COMMISSION ACTION FORM

REQUEST: MAJOR SITE DEVELOPMENT PLAN AMENDMENT FOR 3505 AND 3515 LINCOLN WAY (WALNUT RIDGE)

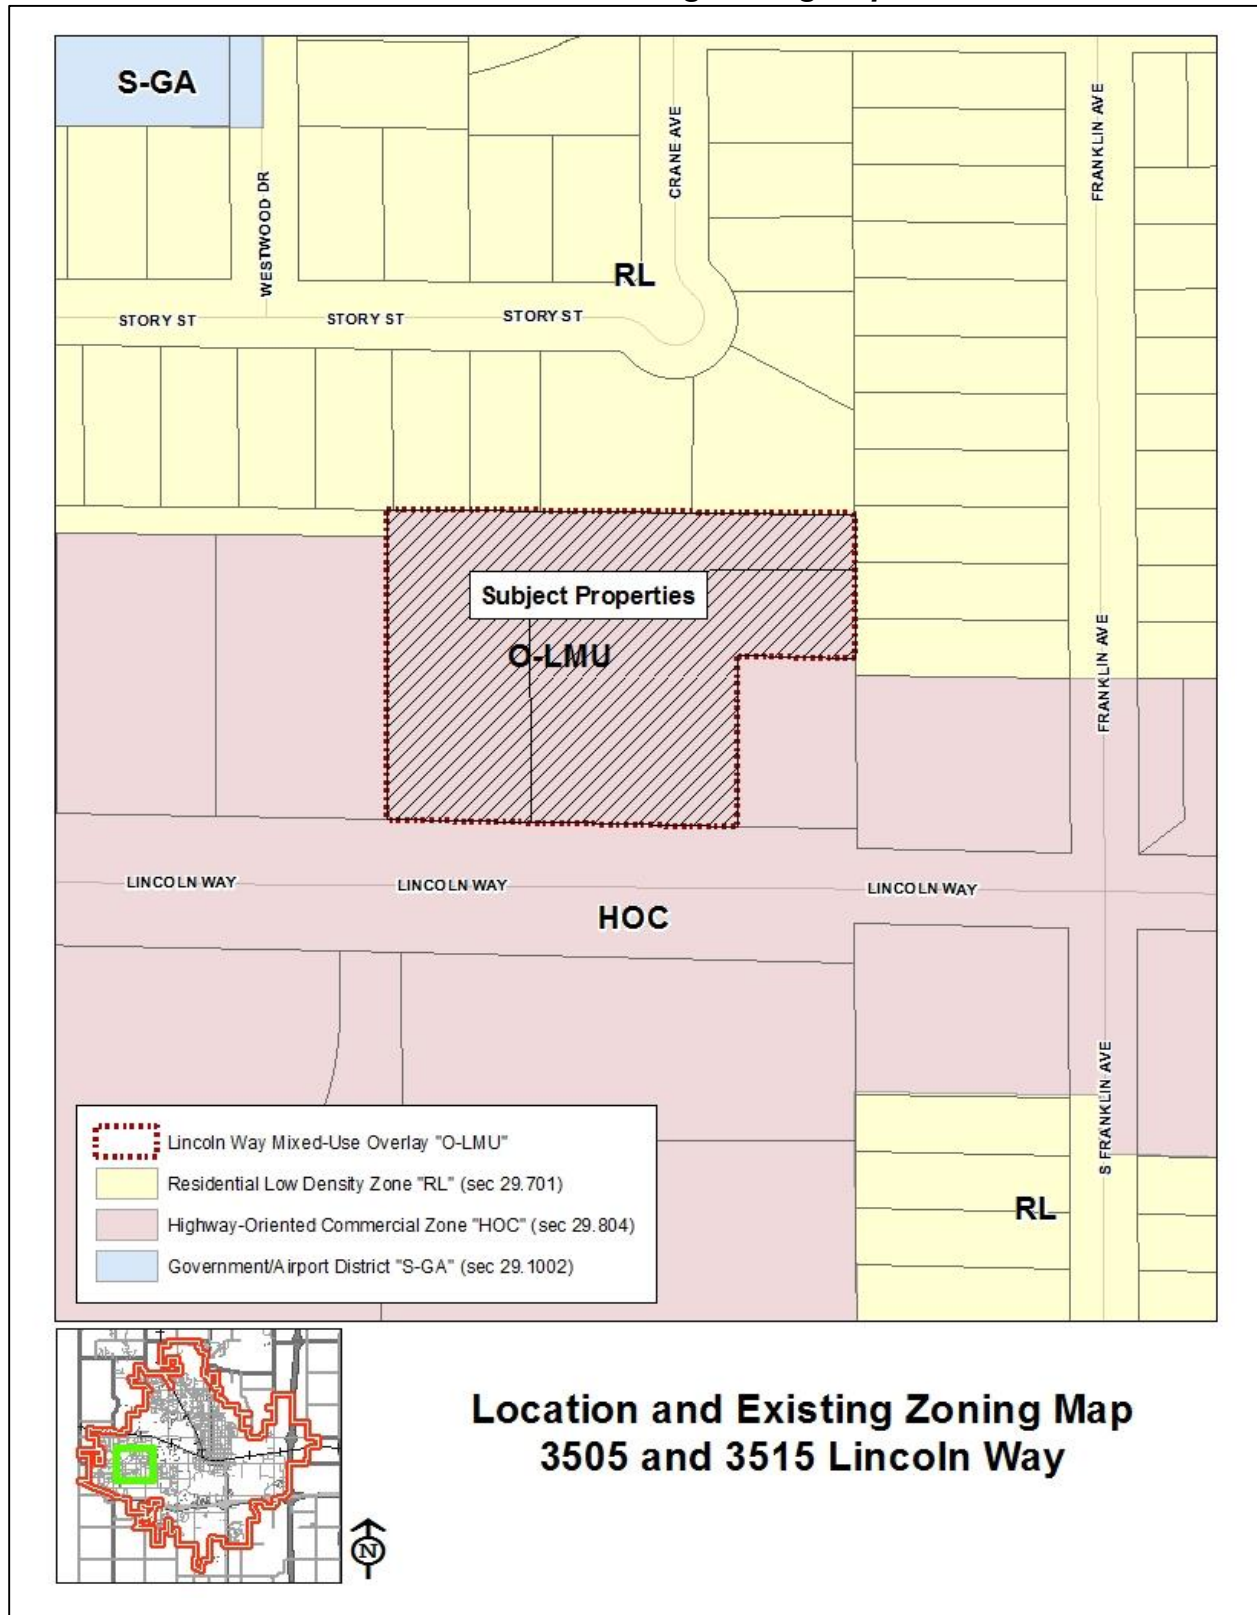
The developer desires to change the L2 screen along the west property line due to the style of the retaining wall that was constructed that then limited the depth of soil for plantings and the limited physical space along the property line for plants to grow. The parking lot is located on the low side of the 5-6 foot wall so all visibility of parked vehicles from the neighboring property is obstructed in this area due to the wall. The developer proposes only ground cover in this area and to plant only one of two required trees due to the retaining wall location.

The proposed plan includes a revision to the other landscape areas of the site along the north and east property lines to screen the parking lot with the existing 6-foot wood fence and using a mix of grasses and shrubs to meet the intent of the parking lot screen requirements and the use of understory trees. Grasses typically are not counted to meet the minimum screen requirement of an L2 or L3 screen. The east lot line is the most difficult area to address landscaping as the slopes of the detention area limits planting space for such screen requirements. Lower height crabapple trees have been proposed along the north and east property lines to stay below the overhead power lines, but still meet tree requirement of the ordinance for trees within the screen areas.

1. The Planning and Zoning Commission can recommend that the City Council approve the Major Site Development Plan Amendment for 3505 and 3515 Lincoln Way to allow for the proposed revision to the Landscape Plan with the following condition:
 - A. The developer is responsible for the construction and maintenance of the 6-foot along all residential property lines.
2. The Planning and Zoning Commission can recommend that the City Council deny the request for the Major Site Development Plan Amendment for 3505 and 3515 Lincoln Way.
